DWR EXHIBIT M
Informal Submissions, Carl Nuzman
August 7, 2003

Subject: Wichita recharge and recovery

A meeting was held with Carl Nuzman this date. He has been retained by the GMD 2 board to assess the technical merits of the applications for permit to divert source water from the Little Ark. River, recharge it to the Equus Beds, and subsequently recover it.

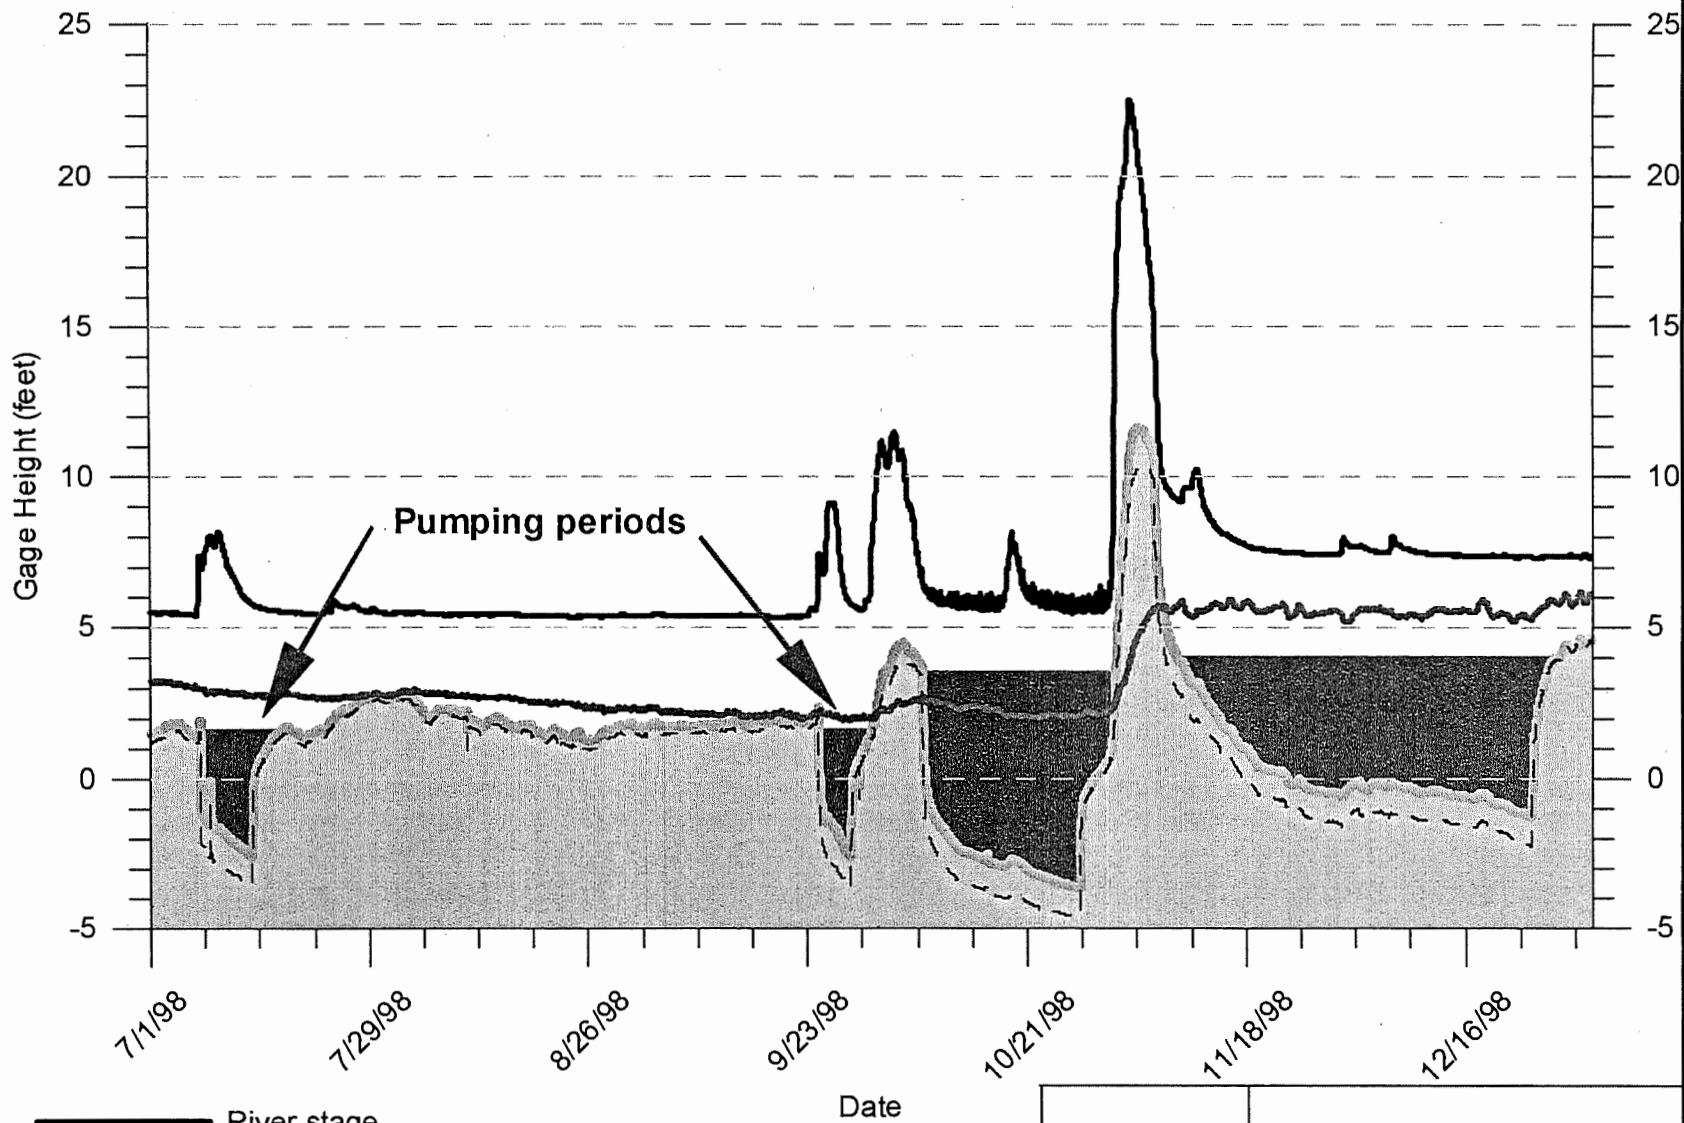
Initial concerns were expressed about the depth of the bank storage wells under the term permit for the pilot project. The wells are drilled to the base of the Equus beds aquifer and screened substantially below the streambed. It is his argument that well logs indicate low permeability clay layers of substantial thickness exist between the top of the screen and the stream, effectively eliminating the hydraulic connection between the wells and the water temporarily stored in the banks. He further argues that the present design merely withdraws water from one location of the Equus Beds aquifer and injects it at another location capturing no stream runoff water. Well log data submitted shows clay layers of about 30 feet with a thin sand layer of less than 10 feet above the clay. About 10 feet of clay also is shown between the stream bed and the sand layer.

His conclusion is that there is no practical opportunity to pump bank storage water from the clay adjacent to the stream.

Hydrograph of River and Groundwater Levels During pumping and nonpumping periods

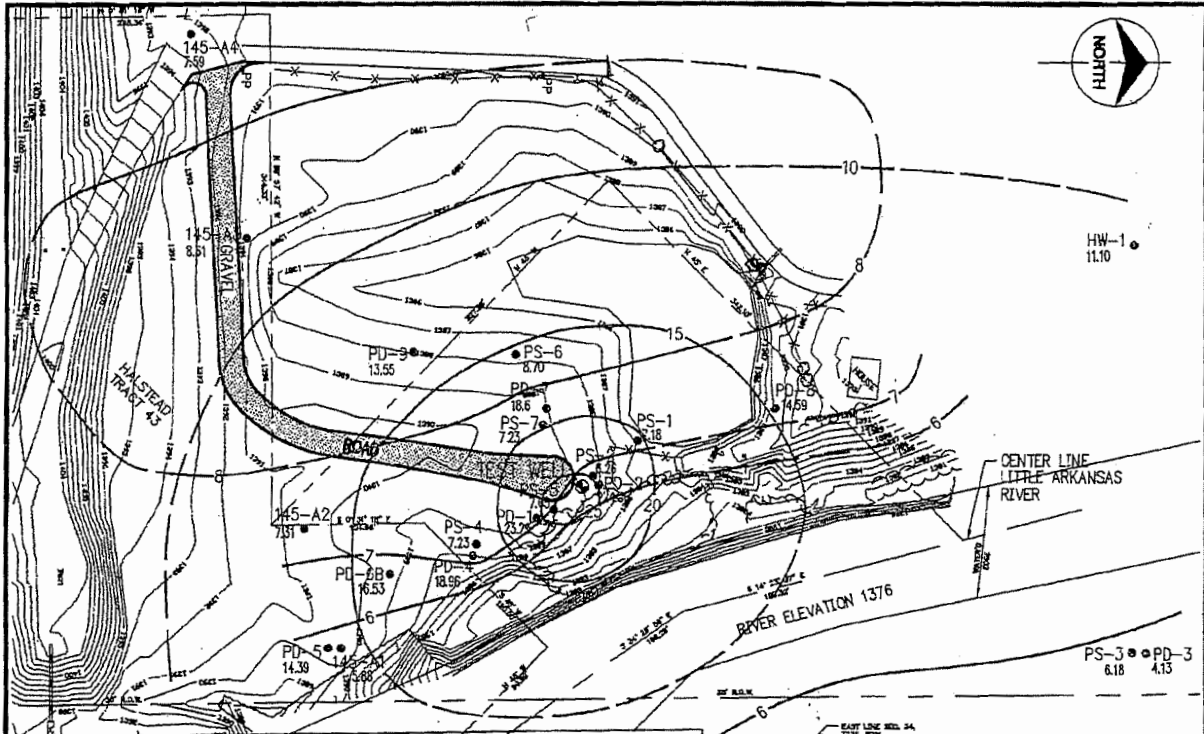
The concern of the consultant and several members of GMD #2 is that no direct communication between the Little Arkansas River and Channel to the Equus Beds aquifer exists at the test site.

The concept of pumping bank storage water only when 40 feet or more of low permeable clay exists between the water in the Little Ark channel and the aquifer is not realistic nor accepted by ~~the~~ ^{the} consultant and was of major concern by several members of the GMD No 2.

The pumping of water for the recharge project was not in compliance with the terms and conditions of term permit File No 959087 in that most of the water pumped was Equus Beds aquifer water recharged from natural precipitation and not limited to "Bank Storage Water" only.
